APPLICATION NO.	FILING DATE	FIRST NAMED INVENTOR	ATTORNEY DOCKET NO.	CONFIRMATION NO.
10/588,974	08/10/2006	Shinichirou Omatsu	294866US3PCT	4629
22850	7590	01/05/2010	EXAMINER	
OBLON, SPIVAK, MCCLELLAND MAIER & NEUSTADT, L.L.P. 1940 DUKE STREET ALEXANDRIA, VA 22314			FRANCIS, FAYE	
ART UNIT		PAPER NUMBER		
3725				
NOTIFICATION DATE		DELIVERY MODE		
01/05/2010		ELECTRONIC

Attachment to PTO-303

FIG. 20

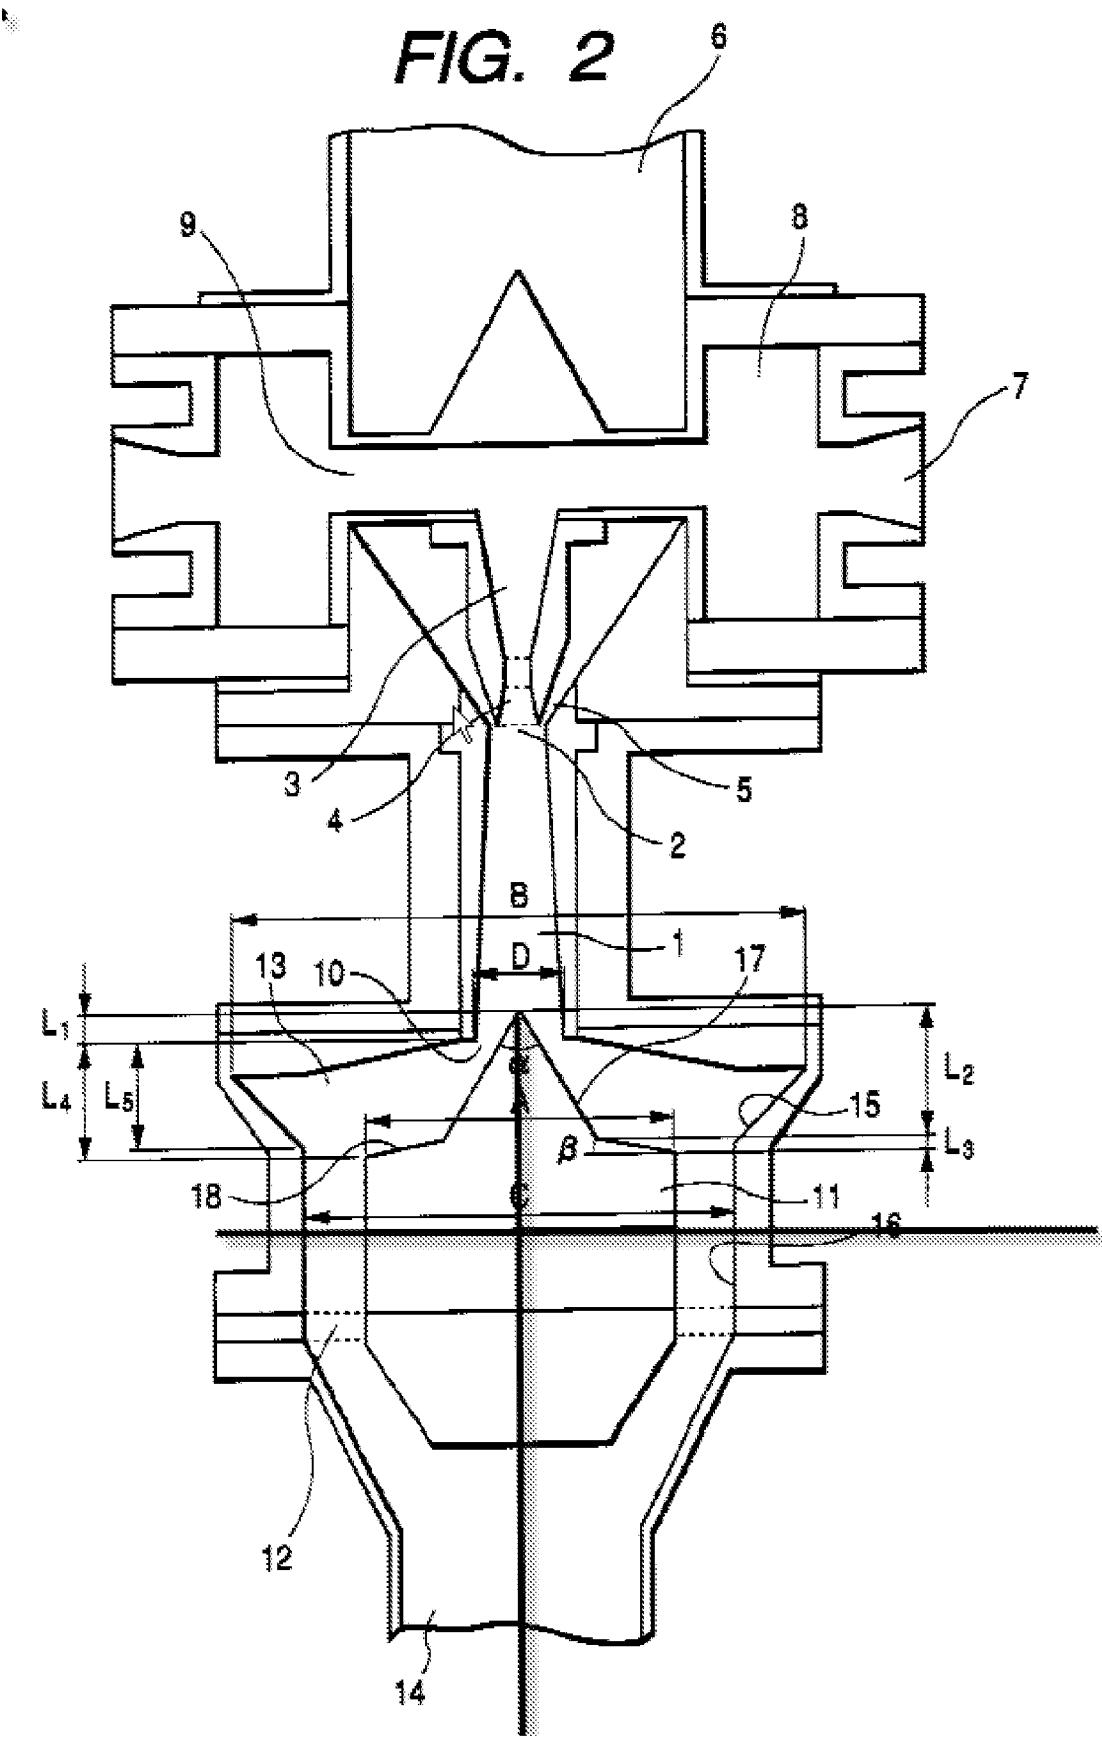
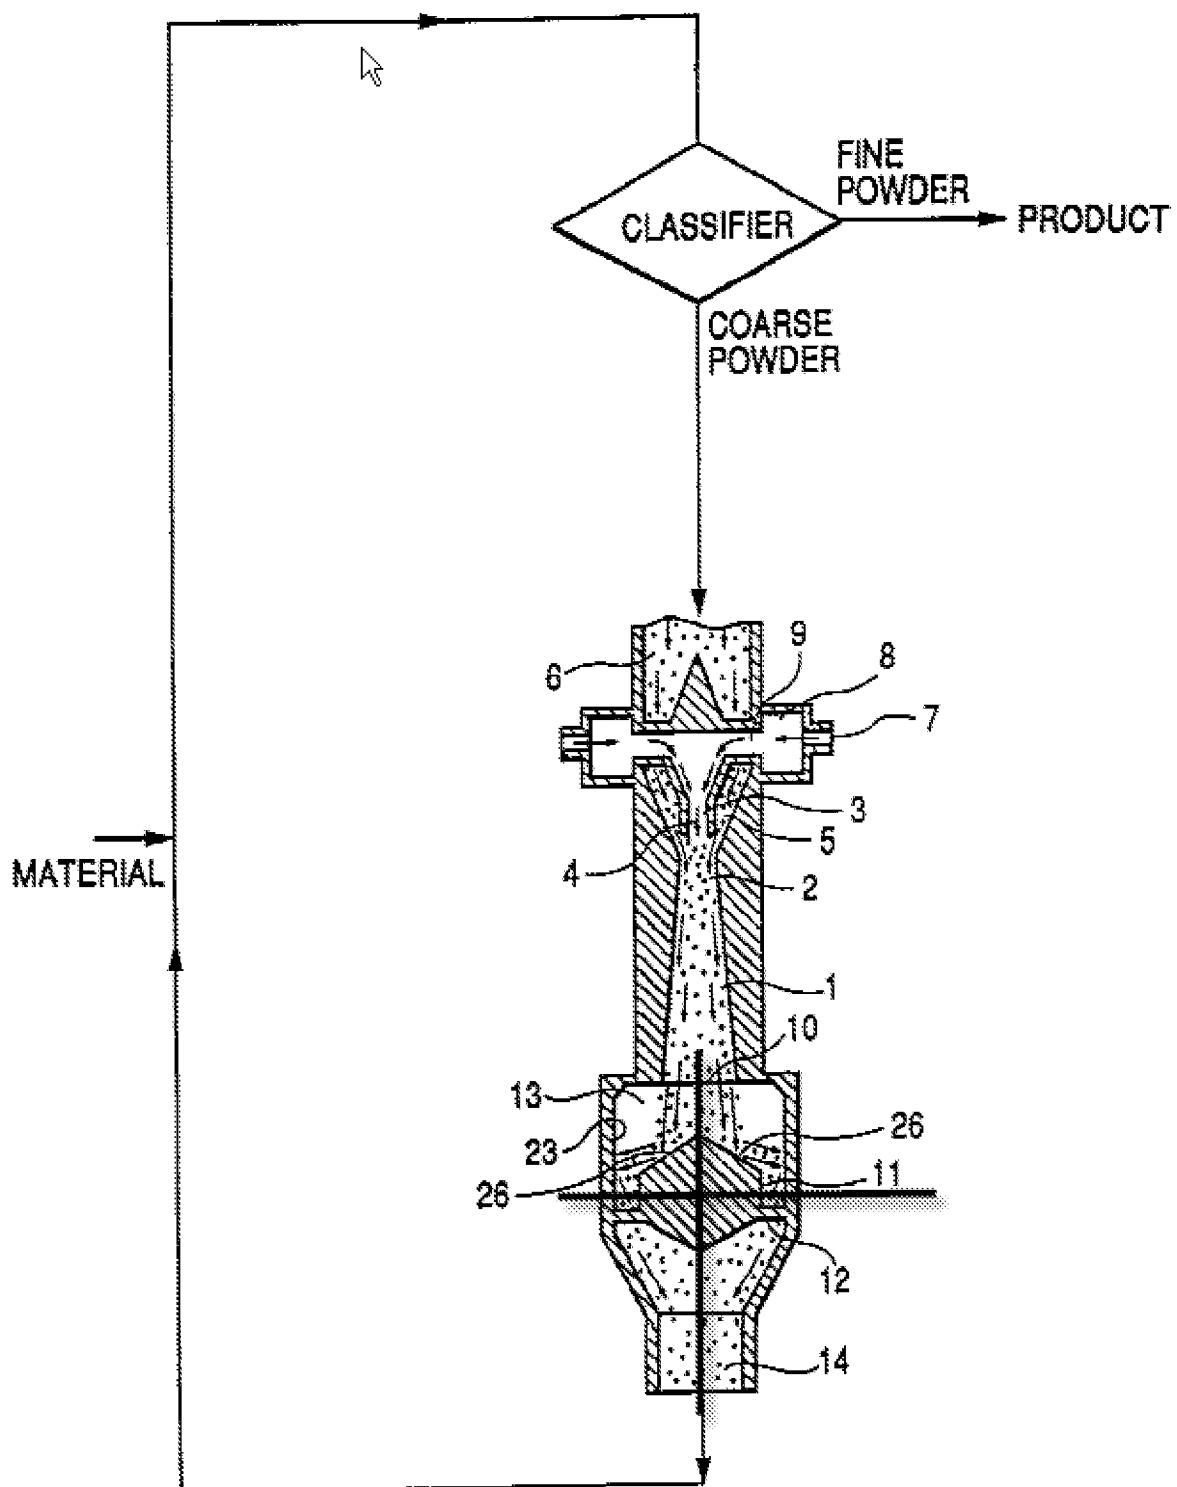
3. In response to applicant's argument that Ohnishi, as shown in Fig. 2, describes a conical member used as a projected central area (17). The axis of the conical member is parallel to a longitudinal axis of the venturi nozzle, the examiner would like to point out that both Fig 2 of the Ohnishi reference and the prior art shown on Figs 20 in Ohnishi reference inherently have two axis one of which is parallel to the longitudinal axis of the venture nozzle and the other one transverse to the longitudinal axis of the venturi nozzle and shown below.
